SPECIAL LETTER 18-20

- SUBJECT:** To ADVISE MOONEY OWNERS/OPERATORS of the **Continental Motors Aircraft Engine SERVICE BULLETIN SB18-04A, Revised Date: 12/18/2018 - Subject: Replacement of Flanged Nut (P/N 652541) Identified with Manufacturer's Stamp "ZB"**.

**SUBJECT:** Replacement of Flanged Nut (P/N 652541)  
 Identified with Manufacturer’s Stamp “ZB”

Figure 2. Flanged Nut, Profiles

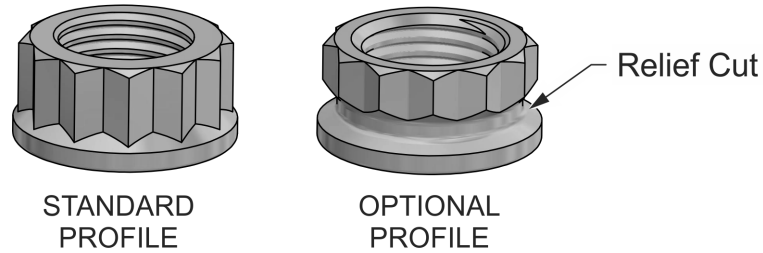
NOTE: Flanged nuts **purchased prior to 1 OCT 2017** or identified with the “OPTIONAL” profile (relief cut, as shown in Figure 2) **do not** require replacement.
